Sumter City-County Planning Commission

MSP-12-30/HCPD-12-26, 185 W. Wesmark Blvd. – Anytime Fitness (City)

Request: Major site plan approval for construction of a 12,600 sq. ft. multi-tenant commercial structure. Plans include paved parking, landscaping and stormwater management.

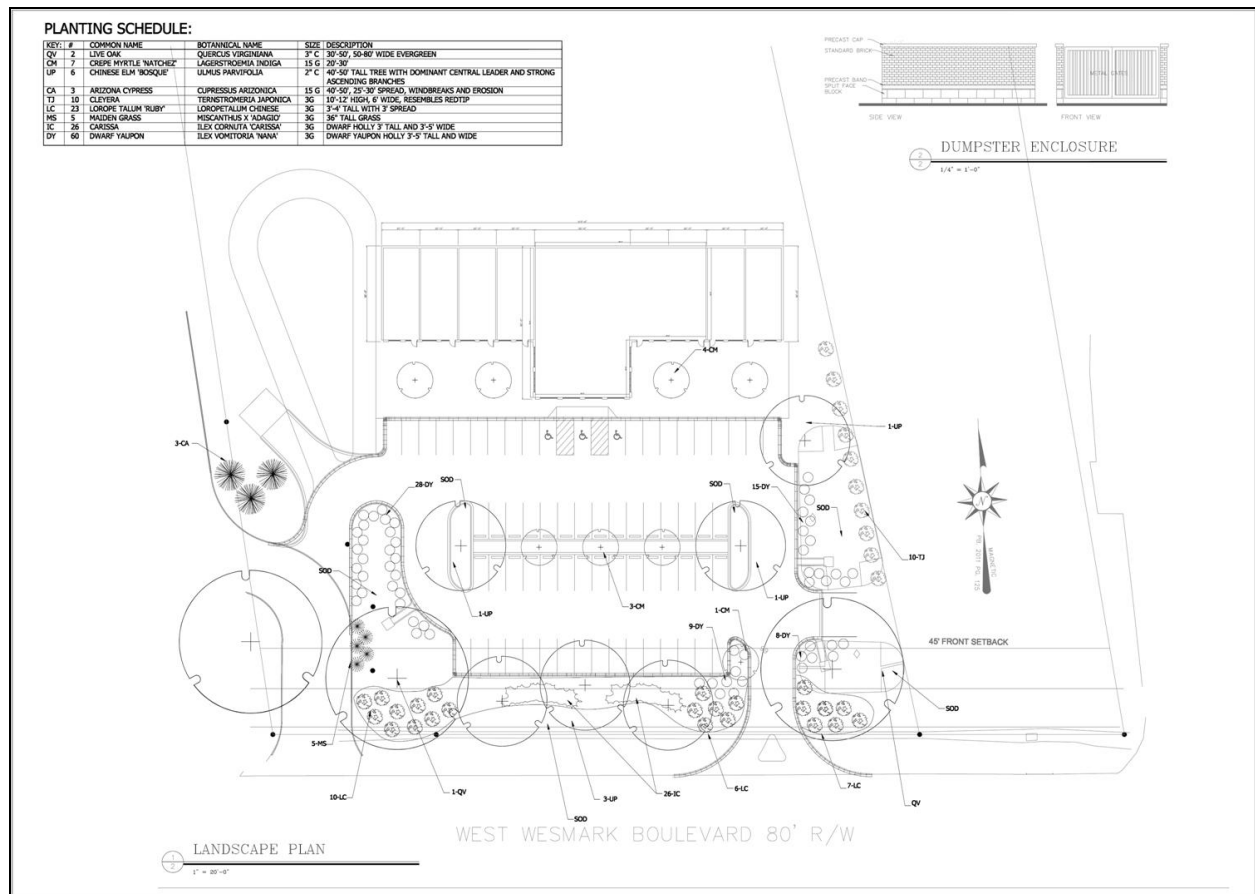
Based on review of the submitted civil plans, the site appears to meet overall development standards as required by the Zoning & Development Standards Ordinance.

Overall, the submitted landscape plan complies with the Ordinance intent, however; due to the proposed dumpster location, Staff recommends additional plantings to screen/mitigate the appearance of the enclosure. Additionally, no notation on the plan indicates whether an irrigation system is planned or proposed. The provision of an irrigation system is a requirement as per Article 8, Section D.

- Revision of the landscape plan to add additional landscape screening around the dumpster enclosure;
- Approval of the stormwater management plan.

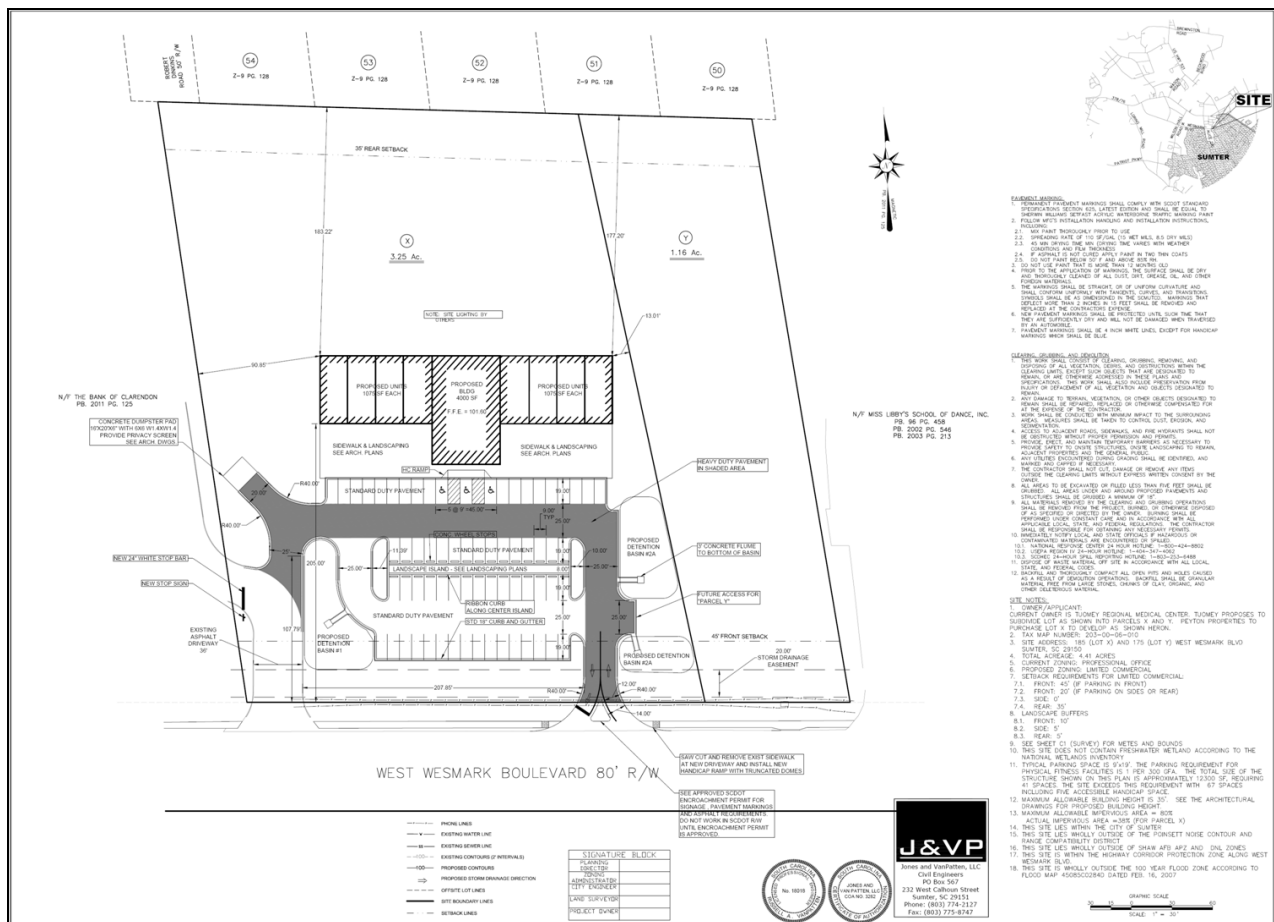
W. Wesmark Blvd. is currently operating at a Level of Service ‘F’, however; prior development on the parent parcel that this 3.25 acres is to be subdivided from necessitated an access plan for the entire tract which includes the 185 W. Wesmark Property. Based upon previous site plan approvals and input from SCDOT, access to the property as shown in the graphic below with inter-parcel access is required. As depicted, there is a shared full access drive with the Bank of Clarendon Parcel to the west and the Right-in/Right-out drive on the eastern side of the tract will be shared access for the parcel to the east. The proposed plan shown below is consistent with SCDOT and previously established development conditions for this tract.

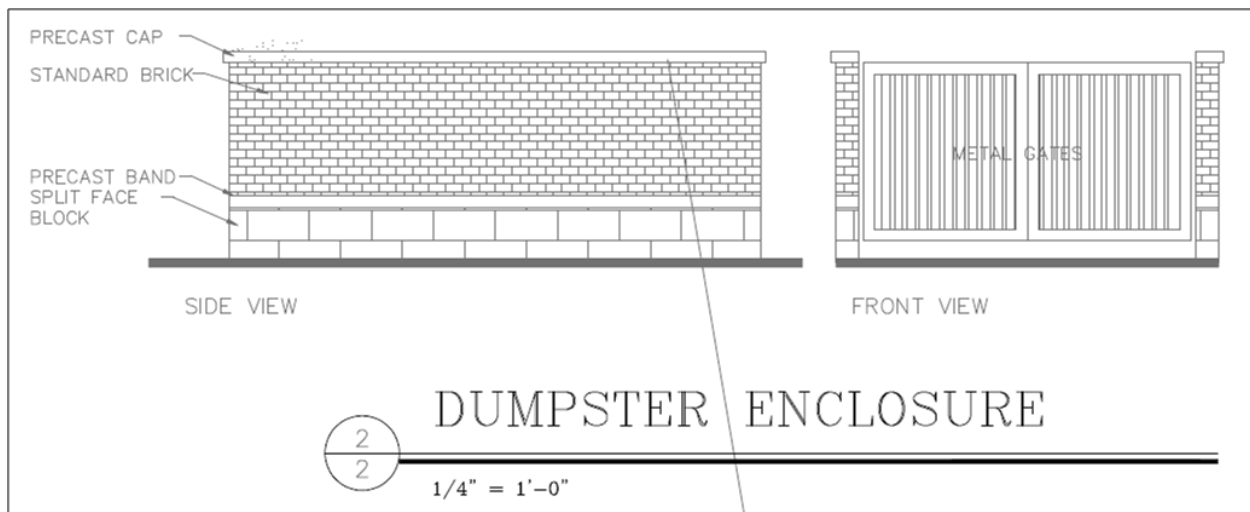
The only fencing/screening wall proposed for this project is the dumpster enclosure as shown in the graphic below. The enclosure will be constructed of split face block and brick with pre-cast concrete top and metal gates.
